Staff Report & Recommendations

Lockwood Meadows Subdivision Lot 35 Accessory Dwelling Unit

Type II Review

(2024-025-ADU) October 9, 2024

Site Plan

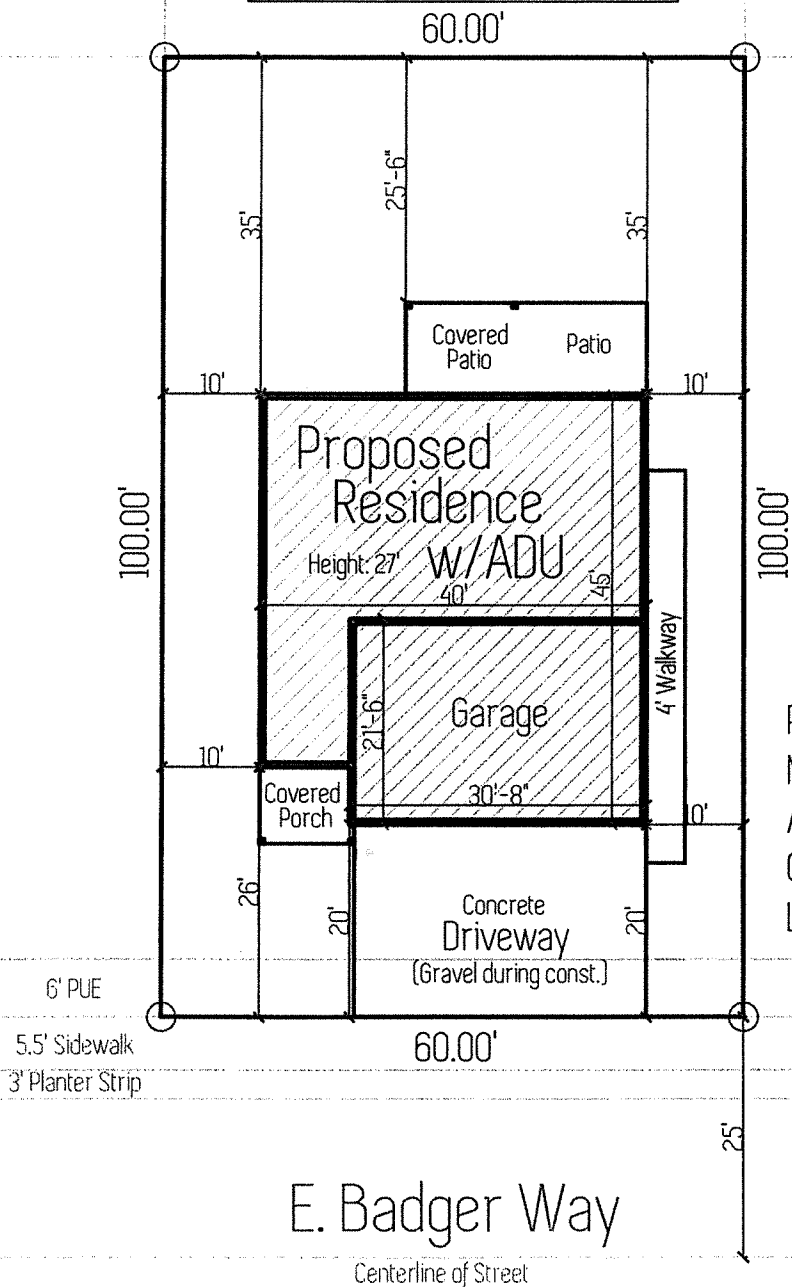
Findings: The proposed attached ADU is located on the east side yard of the primary residence. It will be setback approximately ten (10) feet from the interior property line. The setback criteria meets the requirement.

Findings: Single-family dwellings are required by LCMC Table 18.280.030 to have two off-street parking spaces. The proposed home and accessory dwelling unit has a three-car garage and driveway fulfilling this requirement. The ADU will have its own attached one-car garage, exceeding the minimum additional off-street parking requirement.

Findings: As indicated in the provided plans from the applicant, the ADU will take access from the three-car driveway.

Condition 4: The applicant shall construct the driveway improvements as shown on the approved site plan and meet International Fire Code fire access standards prior to issuance of the occupancy permit.
